METROPOLITAN GOVERNMENT OF NASHVILLE AND DAVIDSON COUNTY

STAFF RECOMMENDATION
2001 18th Avenue South
January 16, 2012

Application: Demolition, New construction-accessory Structure and Setback reduction
District: Belmont-Hillsboro Neighborhood Conservation Zoning Overlay
Council District: 18
Map and Parcel Number: 10412021900
Applicant: Michael Ward, Architect
Project Lead: Michelle Taylor, michelle.taylor3@nashville.gov

2001 18th Avenue South, existing outbuilding.

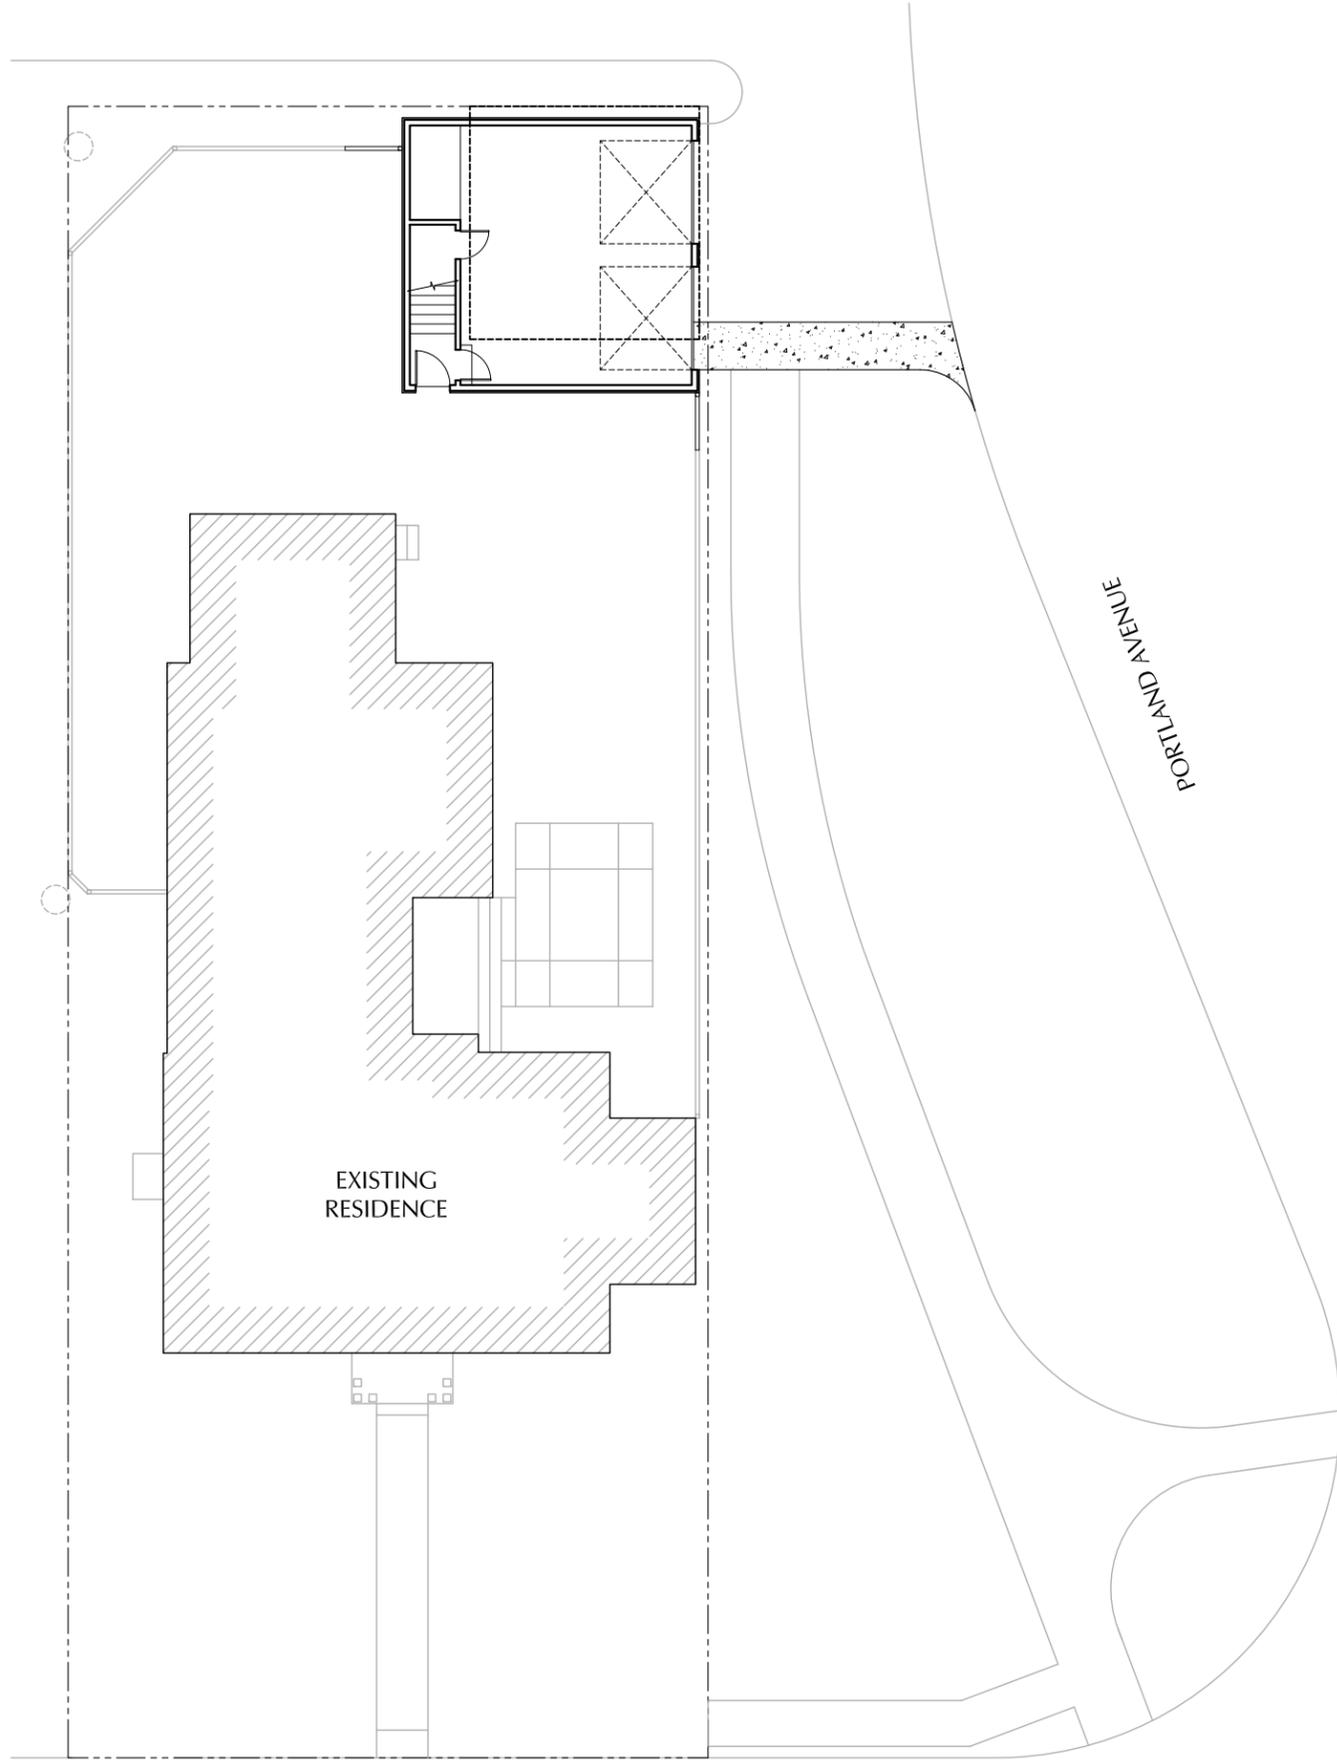
The application involves the demolition of an existing detached garage. The structure is located along the right property line toward the rear of the property and does not contribute to the overall historic character of the property. In order to construct the proposed detached garage the structure would need to be removed. Staff finds that demolition of the outbuilding meets section III.B.2.b. of the design guidelines.

Site Plan

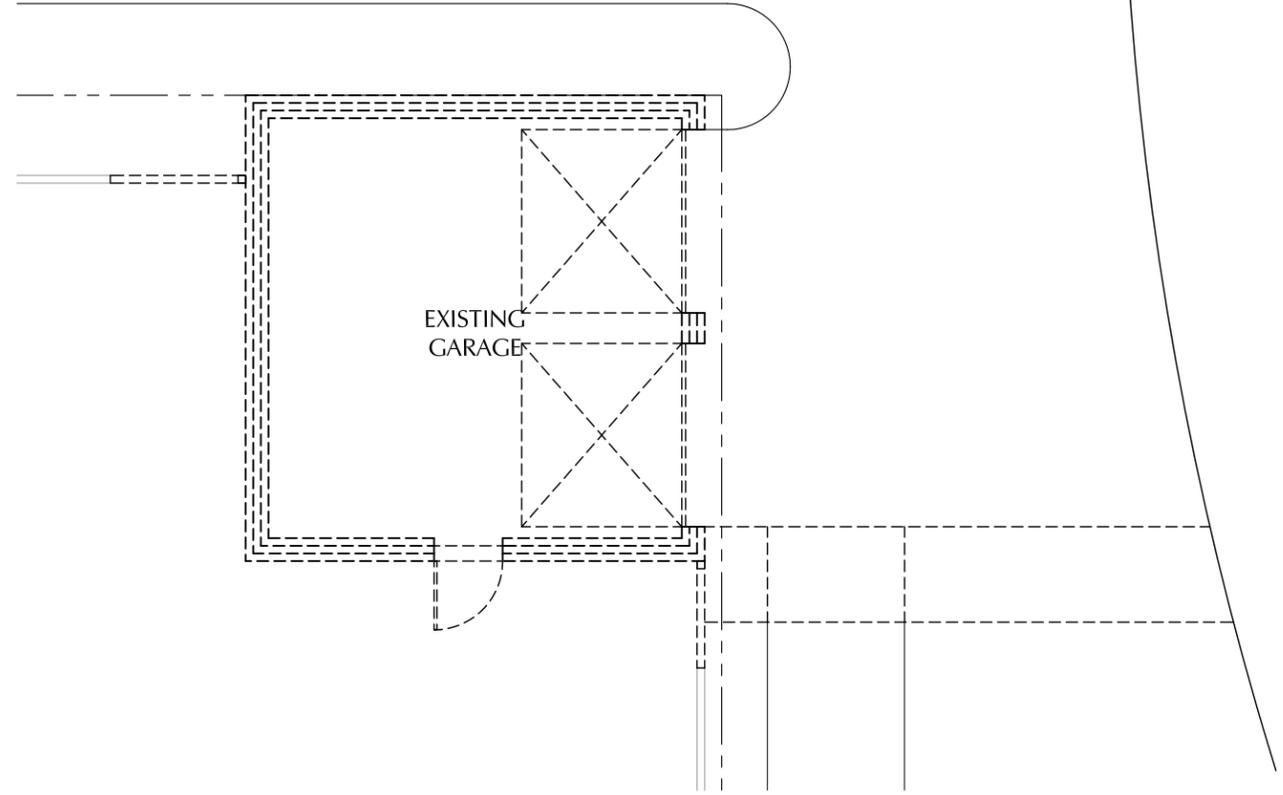
The outbuilding will be located in the same approximate location of an existing outbuilding that is proposed for demolition. The proposed location for the outbuilding meets the required three foot (3') side setback on the left side. However, for structures of this size with street loading, Codes requires a rear setback of three feet (3') and a side setback of twenty feet (20').

As proposed, the outbuilding would be setback two feet (2') on the rear and approximately two feet (2') on the right, which is the street loading side. Staff finds the reduction of the rear and side setback appropriate for several reasons. First, the locations of historic outbuildings were of minimal distance from alleys and streets, and second the structure will be replacing an existing outbuilding, maintaining the existing drive from Portland Street to the garage. Additionally, there is a twenty foot (20') wide public side-

lot between the property line and Portland Avenue, which helps to reduce the perceived lack of a setback. For these reasons, staff finds that the proposed location of the outbuilding is appropriate.

A1.1

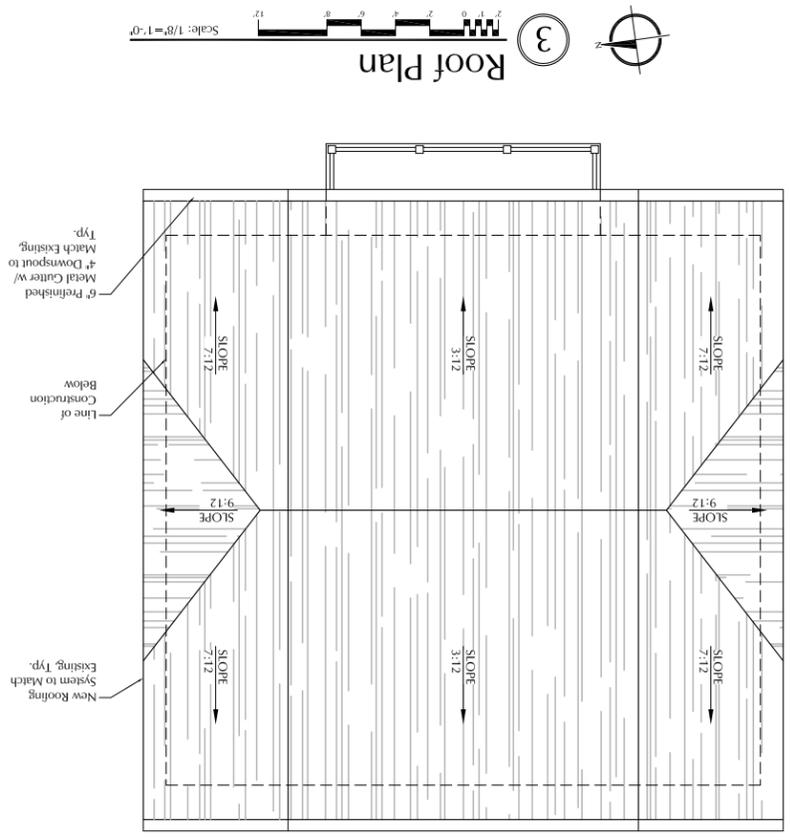
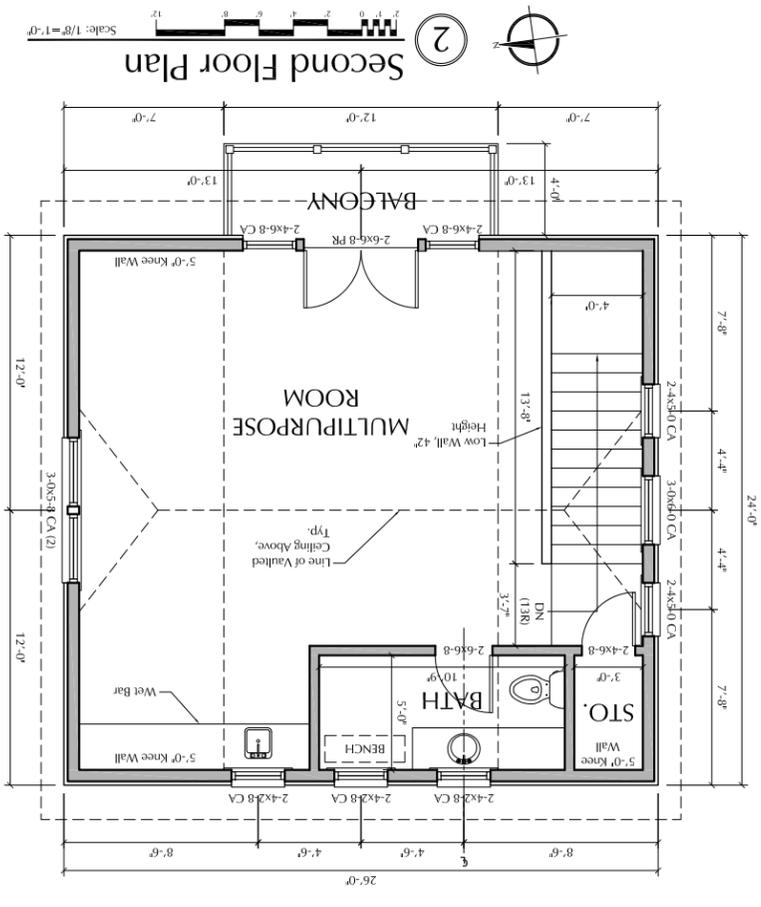
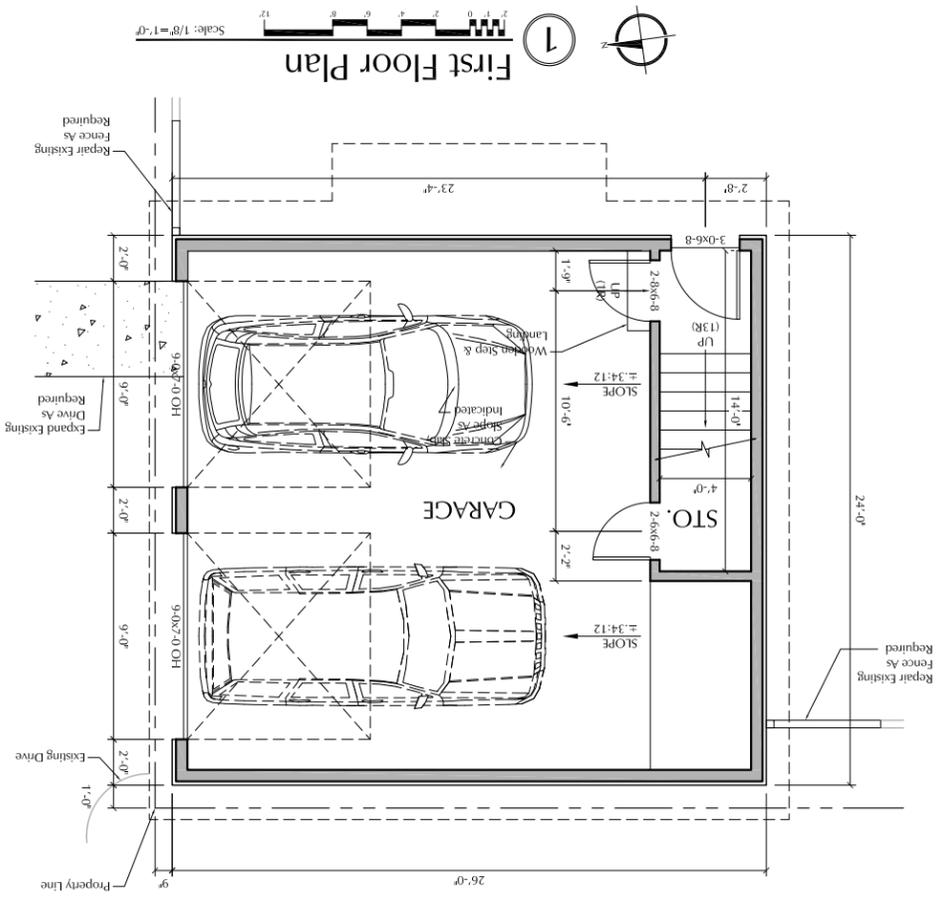
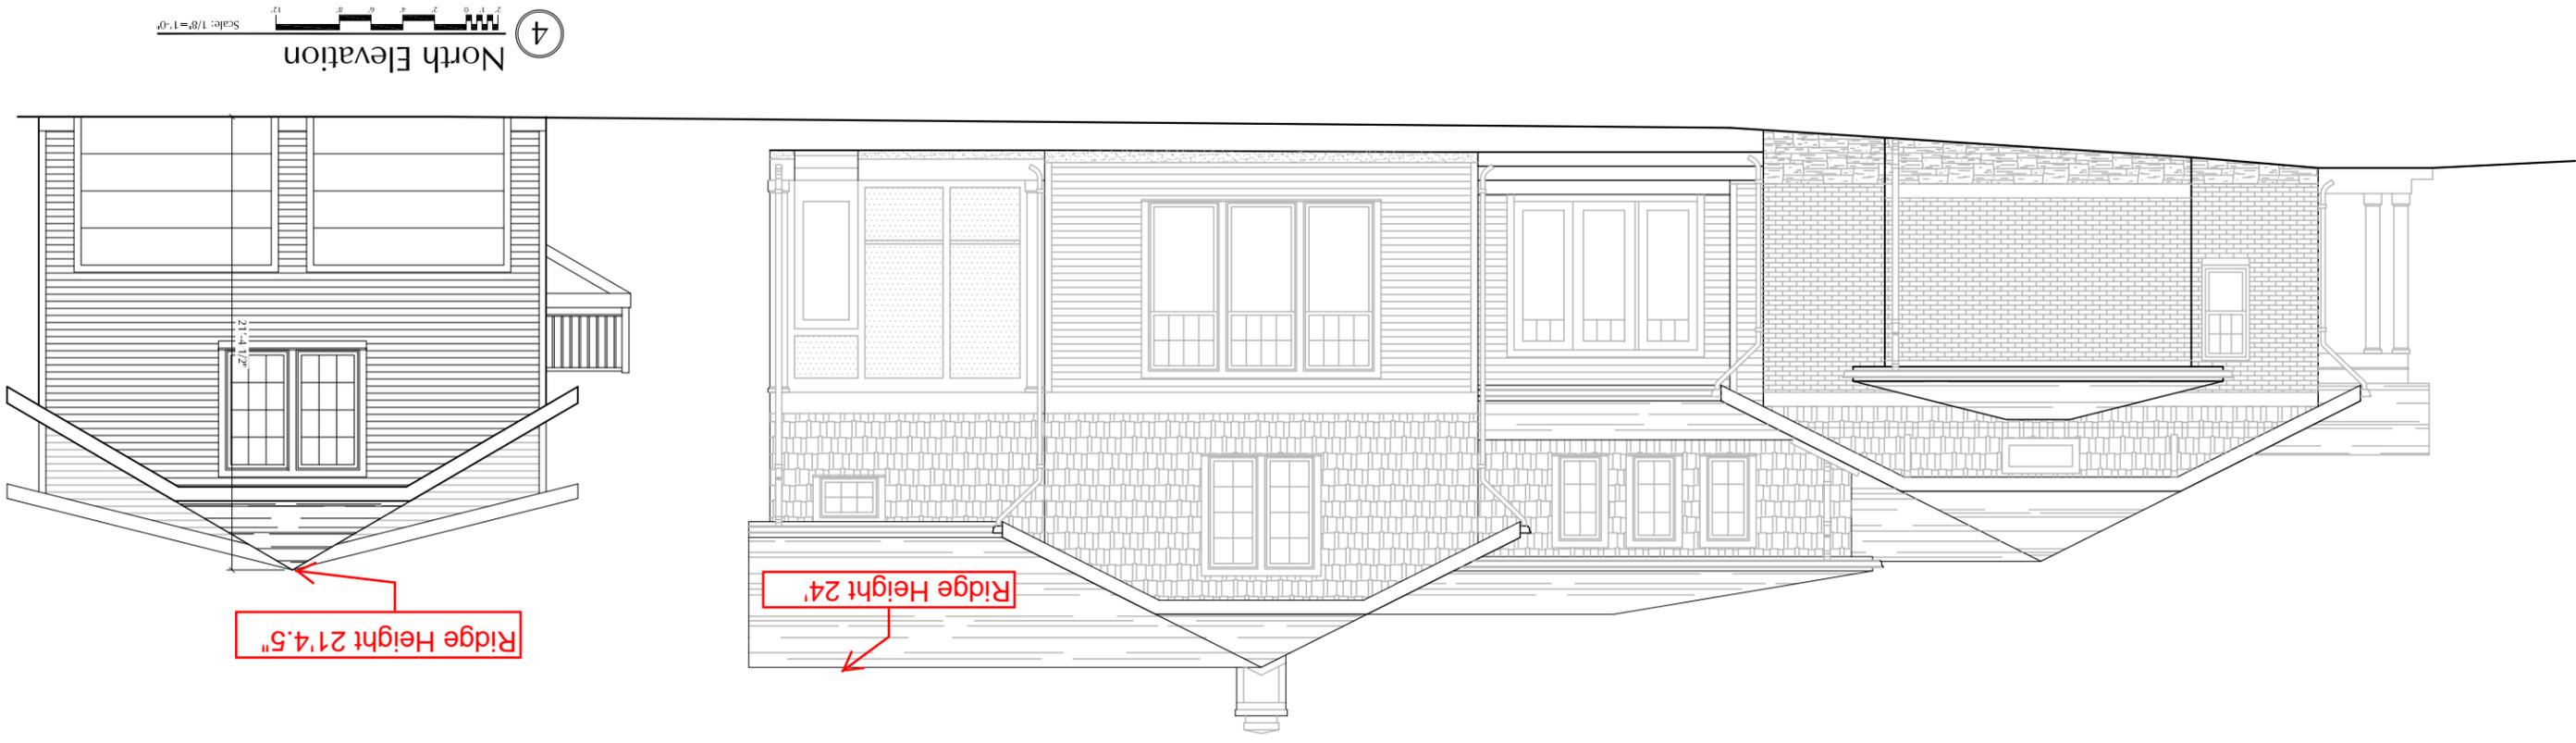
The existing historic house on the property is a one story bungalow with a two story newly approved rear addition (to date, construction of the addition has not been completed). The existing house, taking into consideration the newly approved addition, is approximately twenty four feet (24') at its tallest point and has a footprint of two thousand three hundred square feet (2,300 sq. ft.). The proposed outbuilding is a one and a half story with a twelve foot (12') eave height and a ridge height of twenty one feet, four and a half inches (21'4.5"). The footprint of the outbuilding will be twenty four feet (24') by twenty six feet (26'). In terms of height and scale the outbuilding is subordinate to the main house and similar in scale to historic outbuildings.

The exterior materials of the new outbuilding will be: smooth cement-fiber siding matching the exposure of the existing house, with wood trim. The roof will be composite shingles to match the roof of the existing house, and the foundation will be concrete block. The window and door material is not known at this time. With the condition that staff approves the window and door materials prior to installation, staff finds these materials are compatible with the historic house.

The eight-twelve (7/12) pitch of the clipped gabled roof is typical for the neighborhood and is compatible to that of the existing house. Two dormers are planned but neither are street-facing.

The rhythm of openings matches the surrounding context and is typical of historic outbuildings.

Staff recommends approval of the demolition of the existing outbuilding and construction of the new outbuilding at 2001 18th Avenue South, with the condition that the window and door materials be approved by staff, finding the application to meet sections III.B.2.b and II.B.1.i of the Belmont-Hillsboro Neighborhood Conservation Zoning Overlay design guidelines.
